APPLICATION NO.	FILING DATE	FIRST NAMED INVENTOR	ATTORNEY DOCKET NO.	CONFIRMATION NO.
10/578,642	05/09/2006	Pieter Jan Mark Smidt	NL 031337	1733
24737 7590 10/01/2007 PHILIPS INTELLECTUAL PROPERTY & STANDARDS P.O. BOX 3001			EXAMINER	
			VU, BAO Q	
BRIARCLIFF MANOR, NY 10510		ART UNIT	PAPER NUMBER	
			2838	
			MAIL DATE	DELIVERY MODE
			10/01/2007	PAPER

Application No.	Applicant(s)				
	10/578,642	SMIDT, PIETER JAN MARK				
Office Action Summary	Examiner	Art Unit				
	Bao Q. Vu	2838				
The MAILING DATE of this communication app Period for Reply	The MAILING DATE of this communication appears on the cover sheet with the correspondence address Period for Reply					
A SHORTENED STATUTORY PERIOD FOR REPLY WHICHEVER IS LONGER, FROM THE MAILING DA - Extensions of time may be available under the provisions of 37 CFR 1.13 after SIX (6) MONTHS from the mailing date of this communication. - If NO period for reply is specified above, the maximum statutory period w - Failure to reply within the set or extended period for reply will, by statute, Any reply received by the Office later than three months after the mailing earned patent term adjustment. See 37 CFR 1.704(b).	ATE OF THIS COMMUNICATI

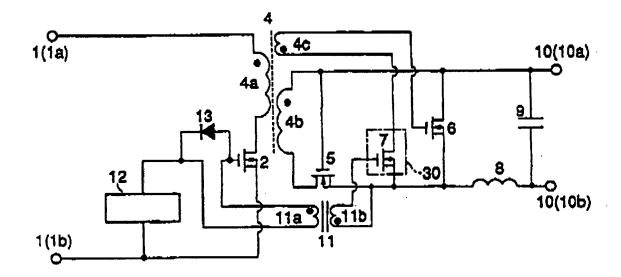
2. The drawings are objected to because the blank boxes 14, 17, 24 and 27. Please insert a short descriptive label for these blank boxes. Corrected drawing sheets in compliance with 37 CFR 1.121(d) are required in reply to the Office action to avoid abandonment of the application. Any amended replacement-drawing sheet should include all of the figures appearing on the immediate prior version of the sheet, even if only one figure is being amended. The figure or figure number of an amended drawing should not be labeled as "amended." If a drawing figure is to be canceled, the appropriate figure must be removed from the replacement sheet, and where necessary, the remaining figures must be renumbered and appropriate changes made to the brief description of the several views of the drawings for consistency. Additional replacement sheets may be necessary to show the renumbering of the remaining figures. Each drawing sheet submitted after the filing date of an application must be labeled in the top margin as either "Replacement Sheet" or "New Sheet" pursuant to 37 CFR 1.121(d). If the examiner does not accept the changes, the applicant will be notified and informed of any required corrective action in the next Office action. The objection to the drawings will not be held in abeyance.
